SERVICE BULLETIN

OIL - REWORK THE ACOC INLET DUCT ASSEMBLY BY INCORPORATING DRAIN HOLES TO PREVENT FLUID ENTRAPMENT - CATEGORY CODE 5 - MOD.ENG-79-0010

V2500-ENG-79-0010

Rework of the Duct, A/O inlet ACOC
Fig.6

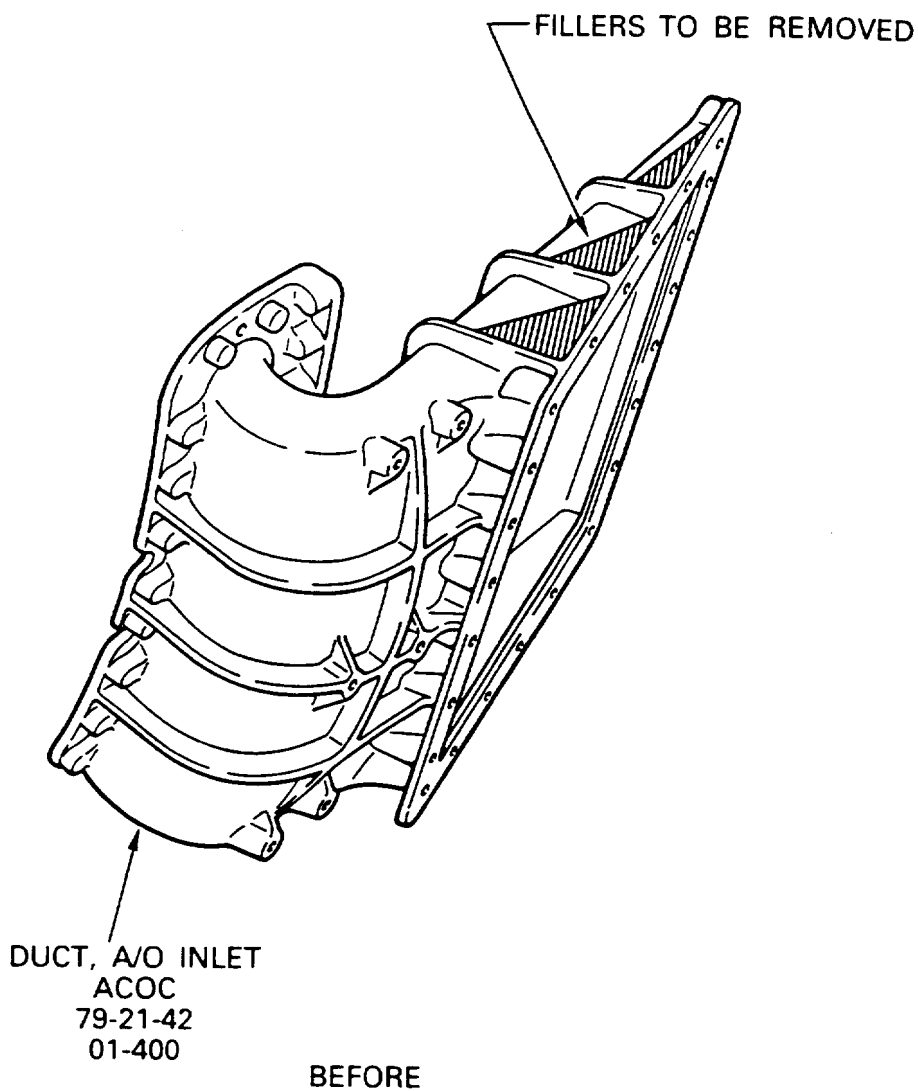
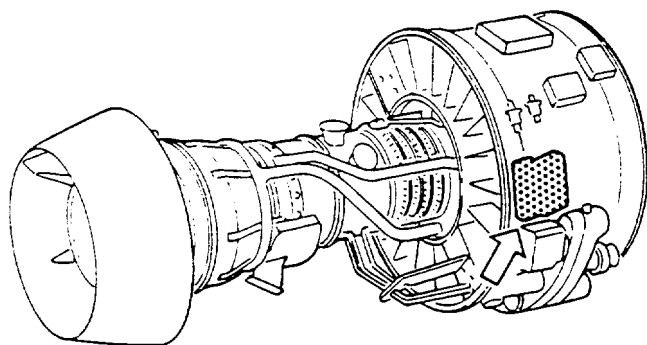
- (h) Renumber 5T0056 adjacent to existing Part Number. Delete 5T0061 with a single line.

Refer to Figure 6.
Use marking pencil, vibrating.
Refer to SPM TASK 70-09-00-400-501.

POSSIBLE EXISTING
MARKING LOCATION.
MARK NEW PART NUMBER
ADJACENT TO EXISTING
PART NUMBER.
DELETE EXISTING PART
NUMBER WITH A SINGLE
LINE.

Before and After views of configuration changes
Fig.1 (Sheet 1 of 2)

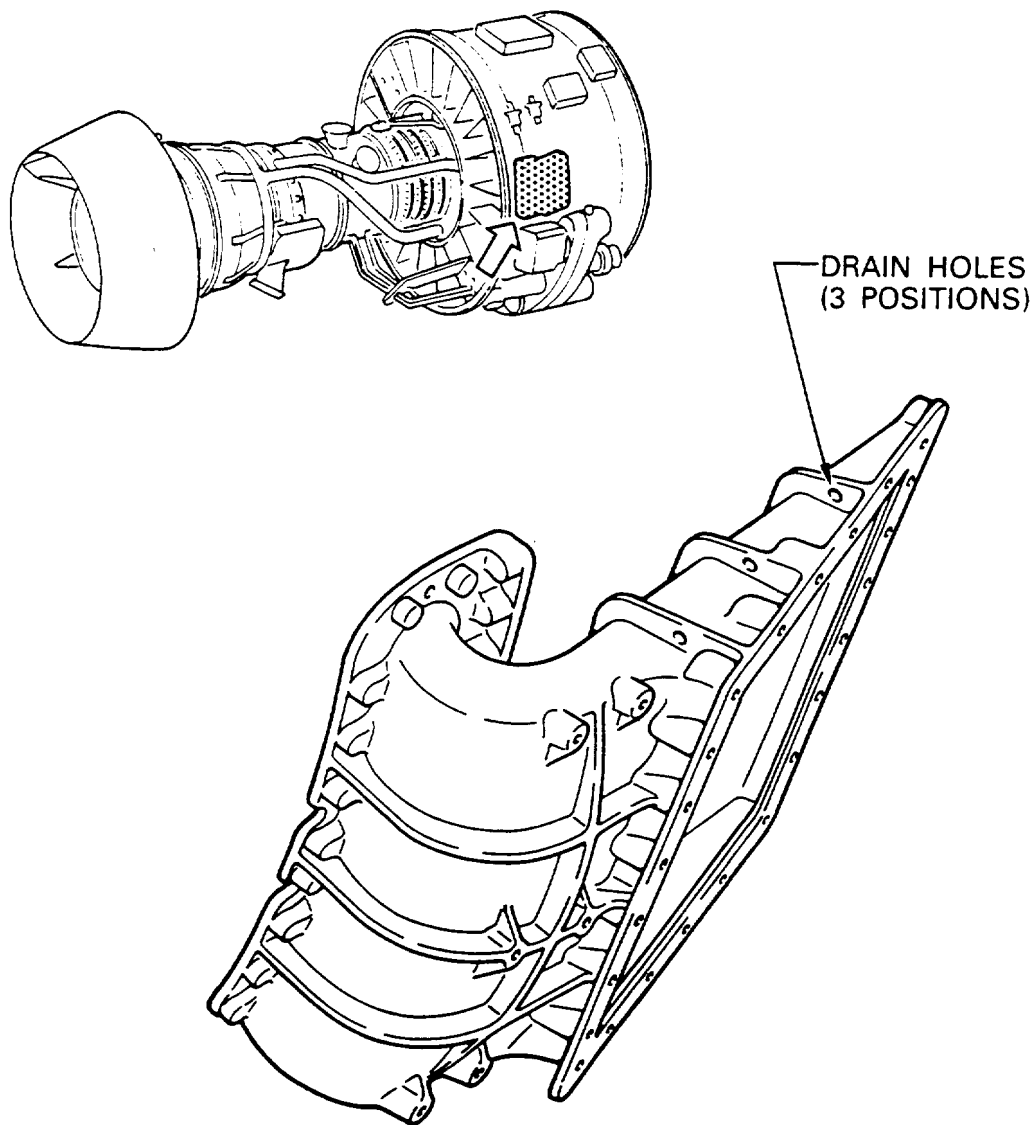
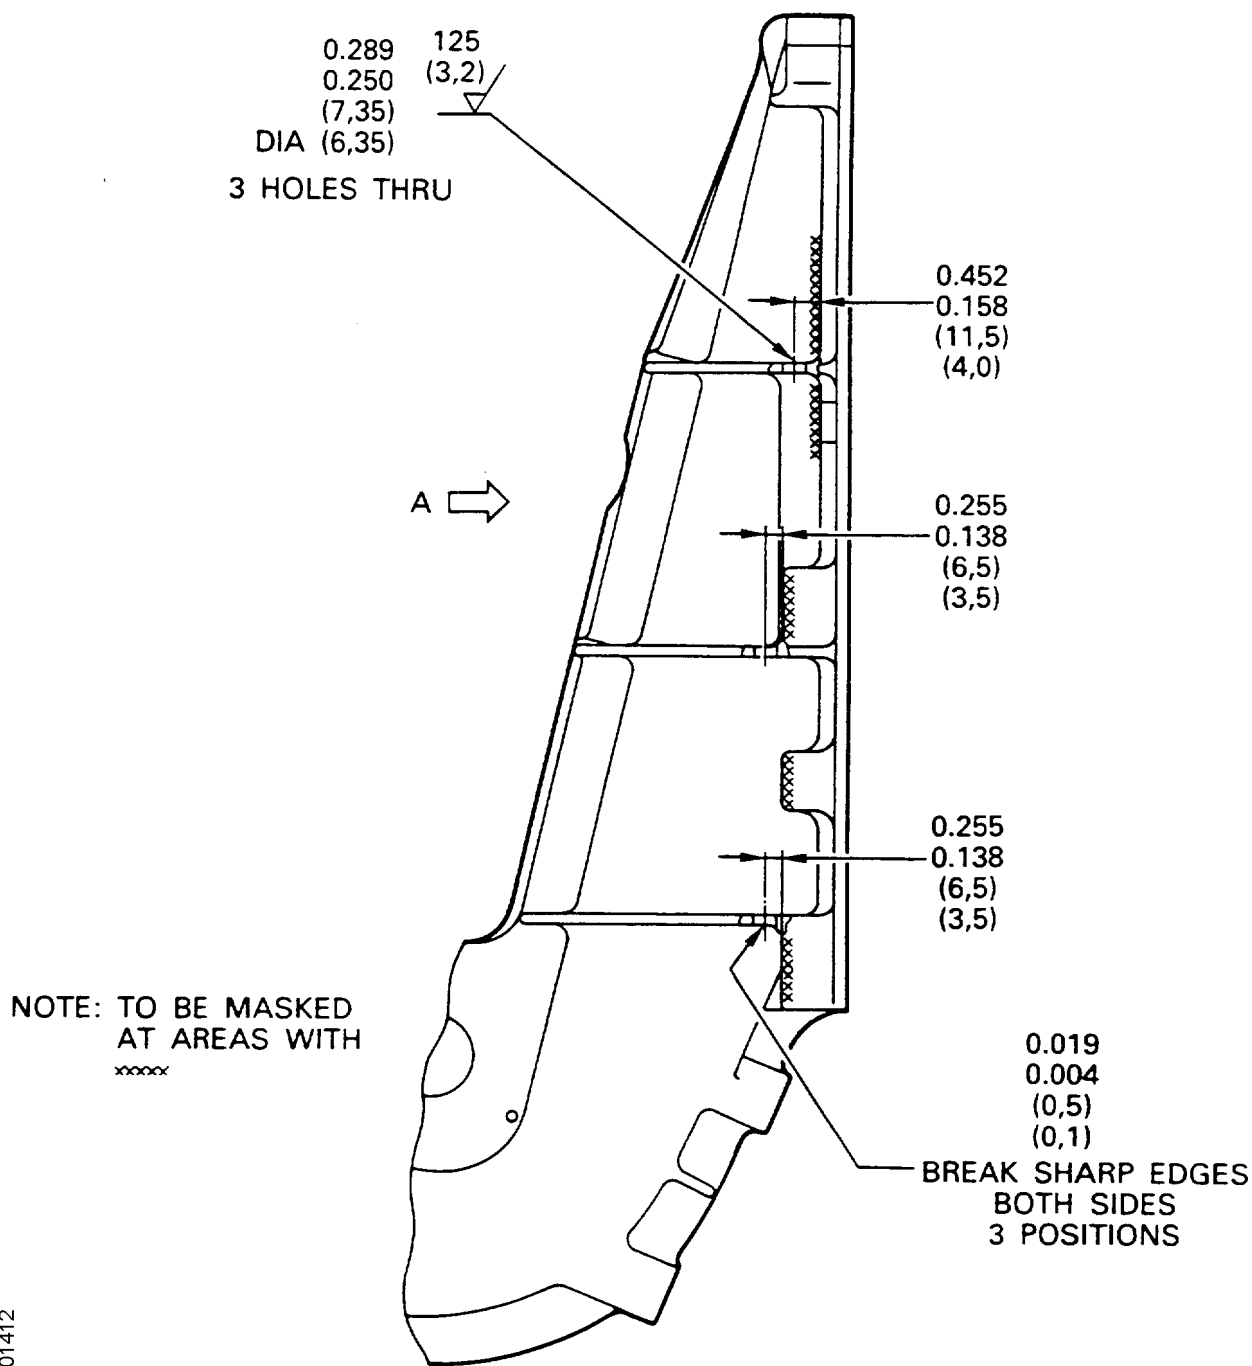
The filters are removed and the drain holes are incorporated to prevent possible fluid traps on the top of the Duct, A/O Inlet ACOC. (See Figure 1).

Procedure	Supplementary Information
(a) Attach the masking tape to prevent surface damage around the filters.	Use CoMat 02-002 Masking Tape. See Figure 1, Sheet 1 of 2.

(b) Remove the filters carefully not to damage the surface of duct.	Use suitable chisel and cutter, RB012 Files, rotary or equivalent.
(c) Clean the surface that the fillers were removed.	Use suitable vacuum cleaner.

Rework of the Duct, A/O inlet ACOC
Fig.2

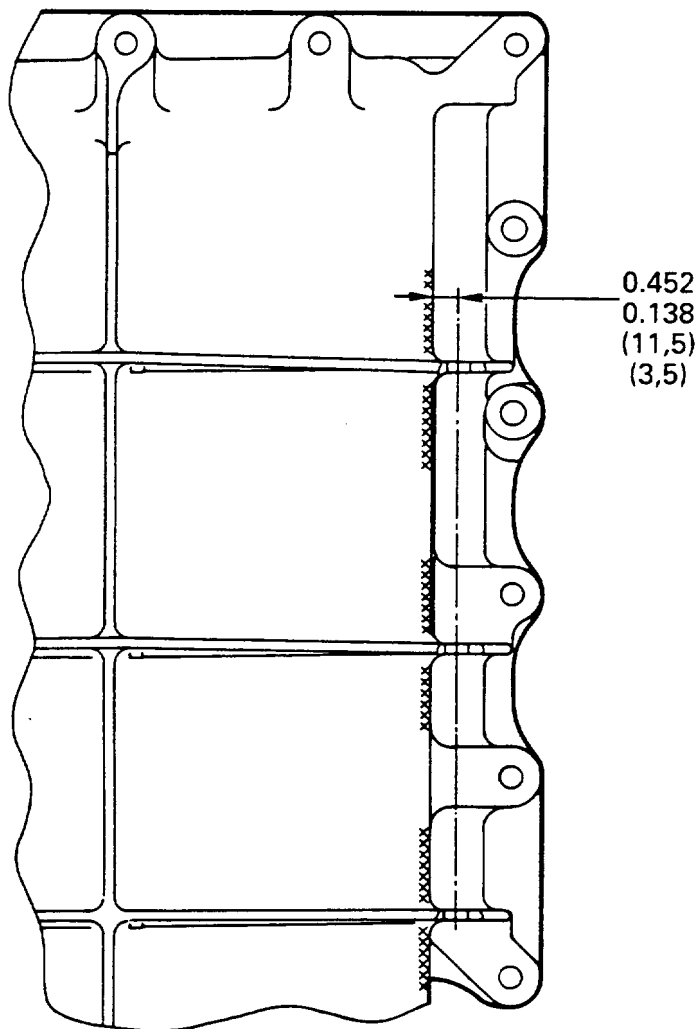
(d) Add the masking tape to prevent the surface damage at the reworked area.	See Figures 2 and 3. Use CoMat 02-002 Masking Tape.
(e) Set-up the reworked positions and make small holes initially less than specified dimensions as the guide. Then make specified holes (3 positions).	See Figures 2 and 3. Special Tool is necessary. See Figures 4 and 5.

(f) Remove the burrs around the holes.	See Figures 2 and 3. Tool: RB010 Grinder, hand held pneumatic or equivalent
Finish the surface of the holes.	
(g) Coat inner surfaces of newly drilled holes with Alodine (Alocrom).	Use CoMat 01-275 Chromate conversion coating (Alocrom). Refer to SPM TASK 70-38-02-300-503.

Rework of the Duct, A/O inlet ACOC
Fig.3

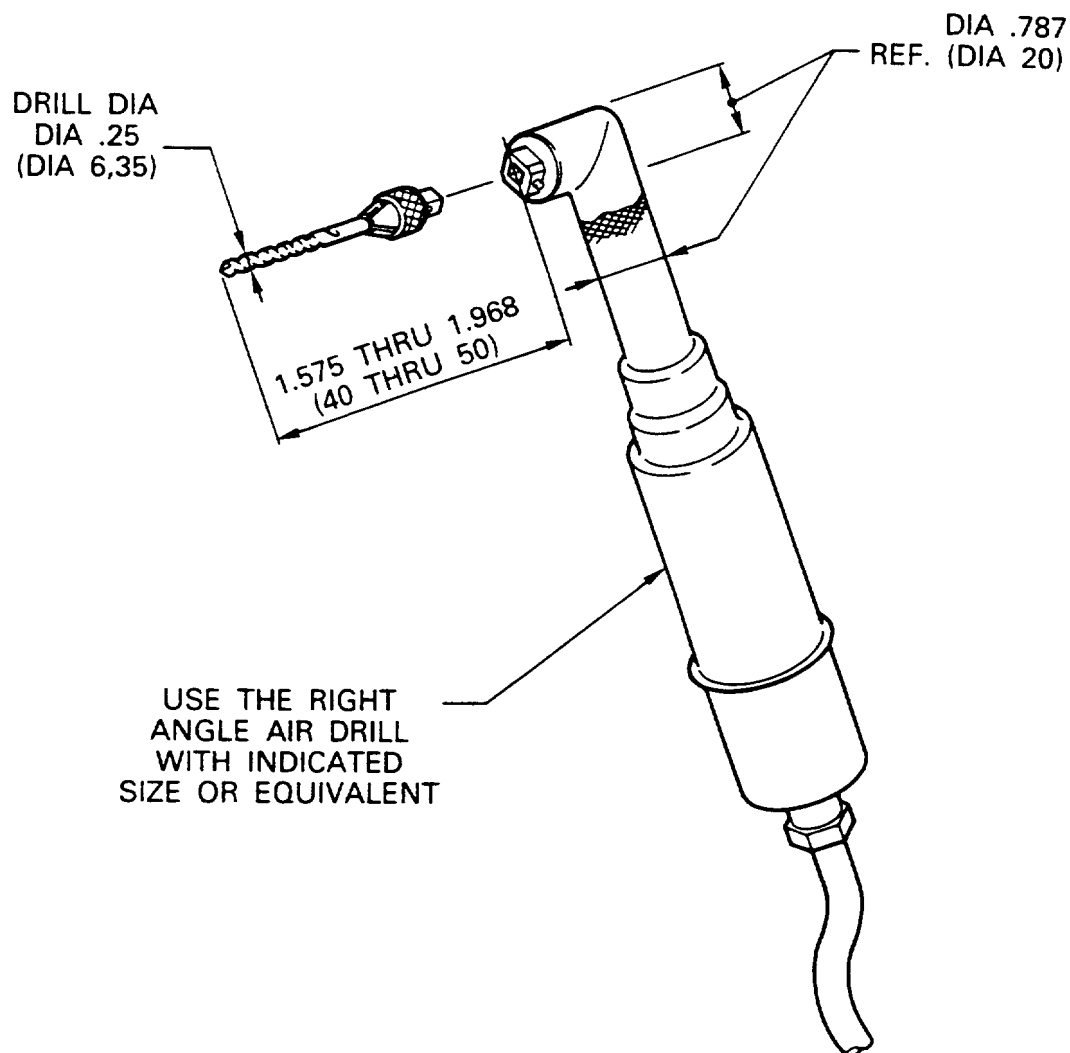
NOTE: TO BE MASKED
AT AREAS WITH xxxxxx
